POND BROOK ESTATES SUBDIVISION

Newtown, Connecticut

Environmental Review Team Report

November 2002

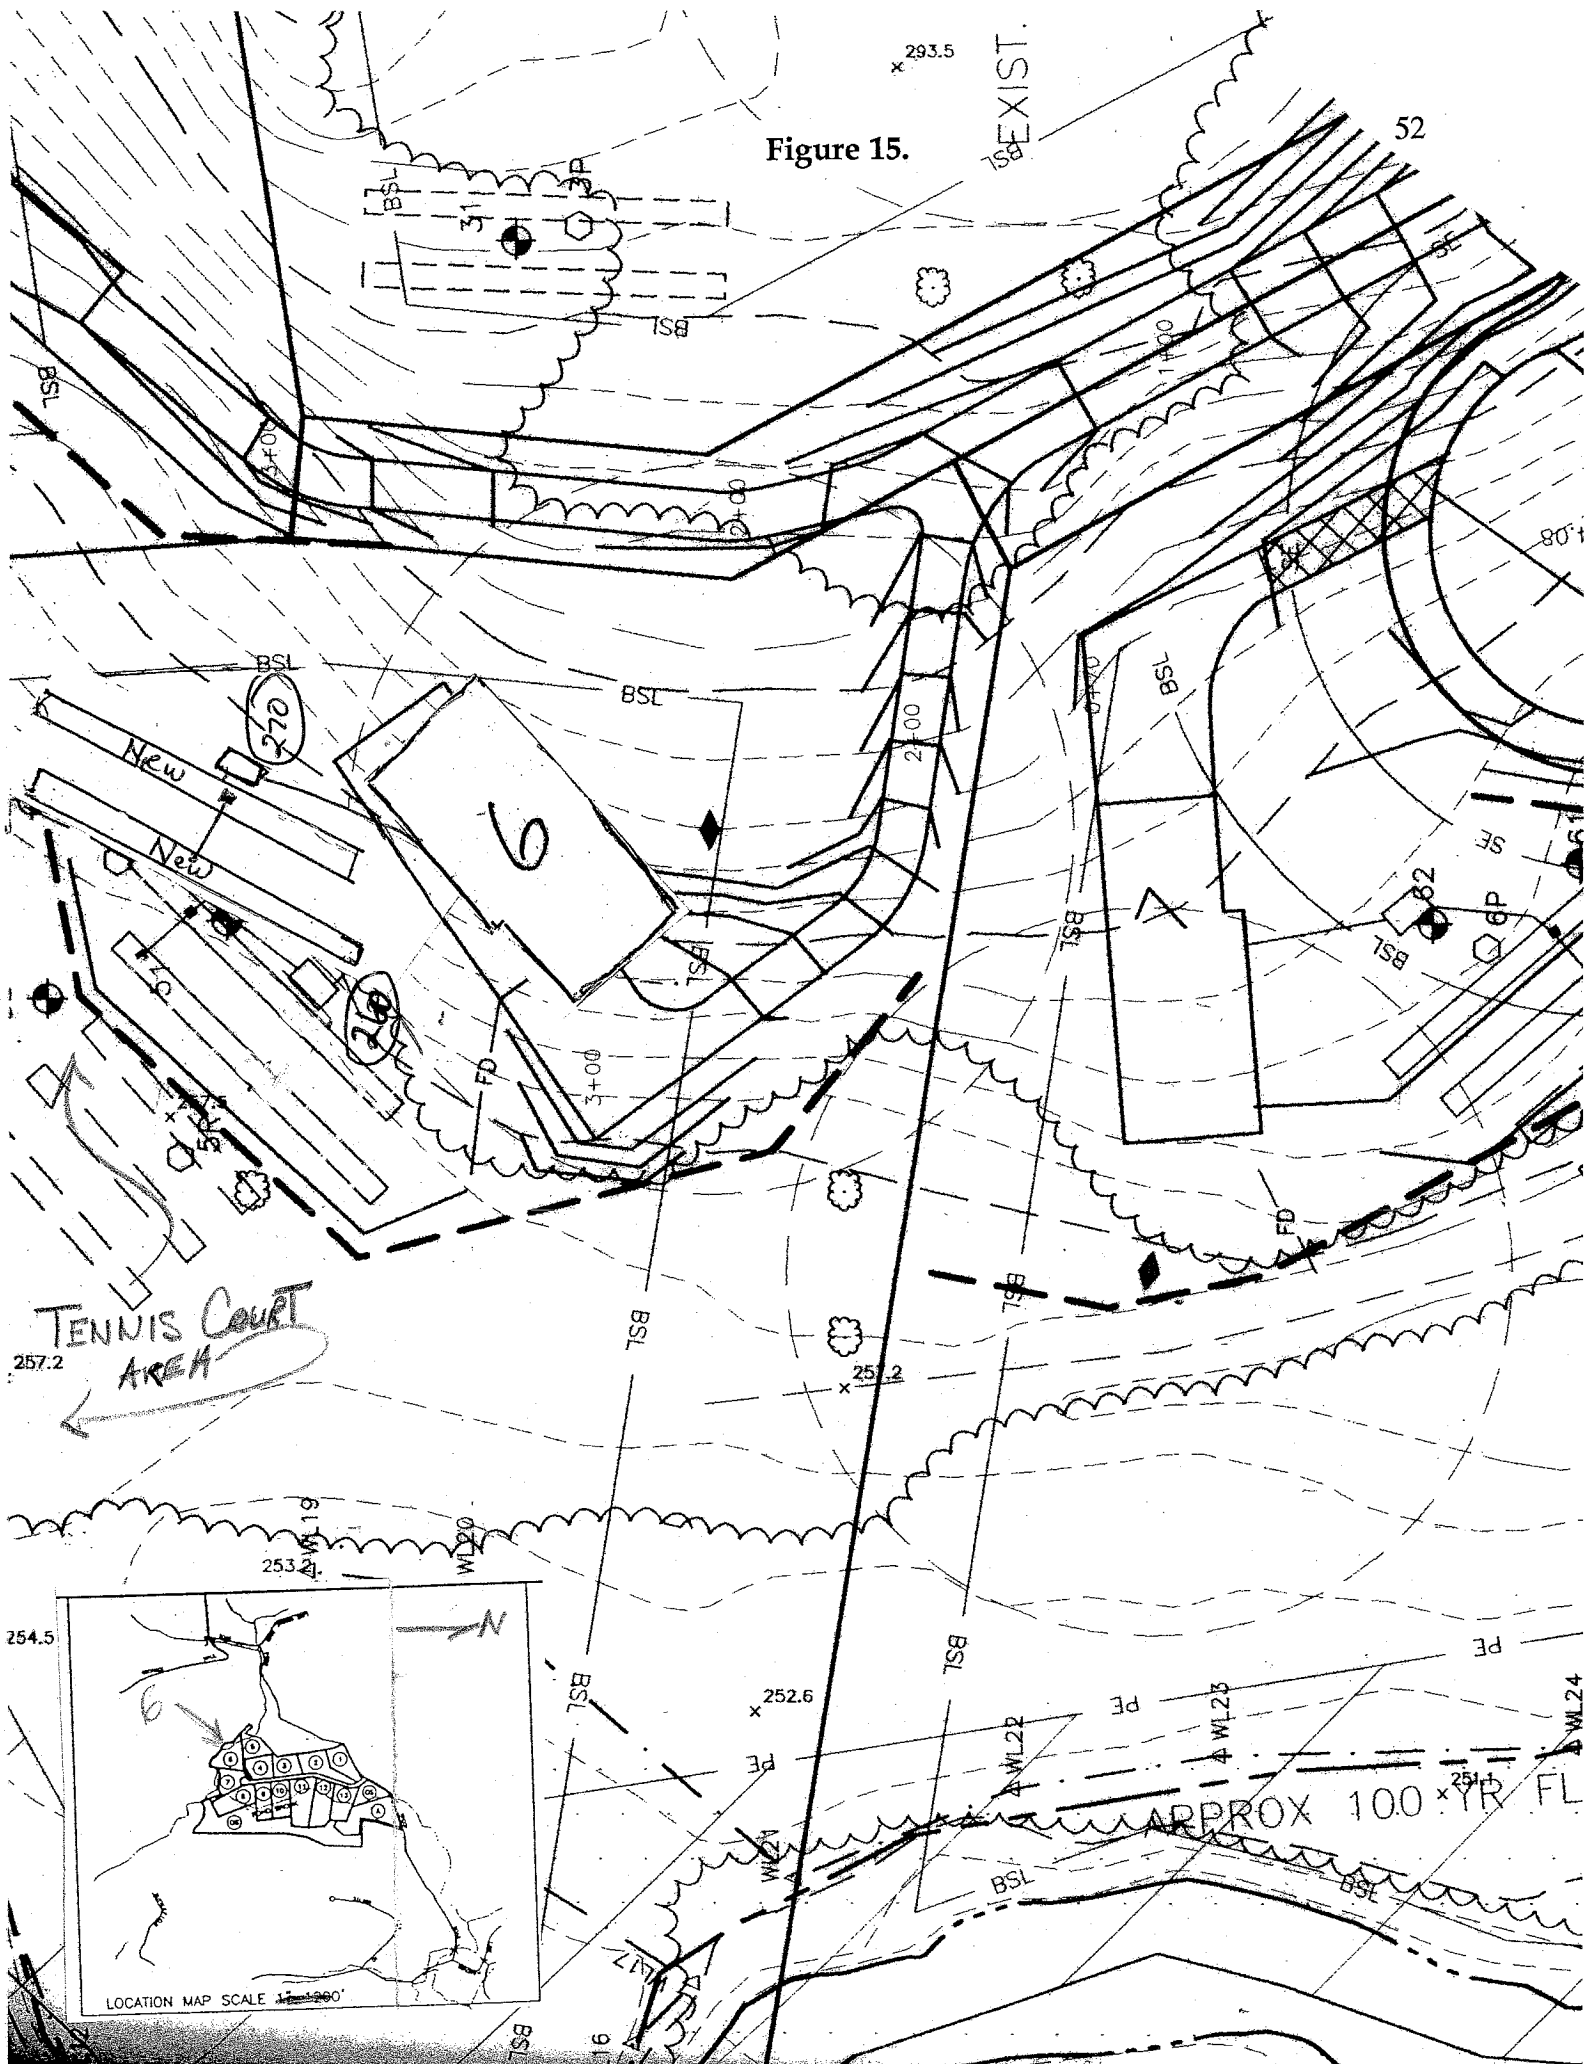
- **"Tennis court area" (Lot #6)** - Part of the septic system is shown in the so-called tennis court area. Consider moving the septic system between the 260 foot and 270 foot elevation, keeping the footprint of the building in approximately the same location. (See Figure 15)
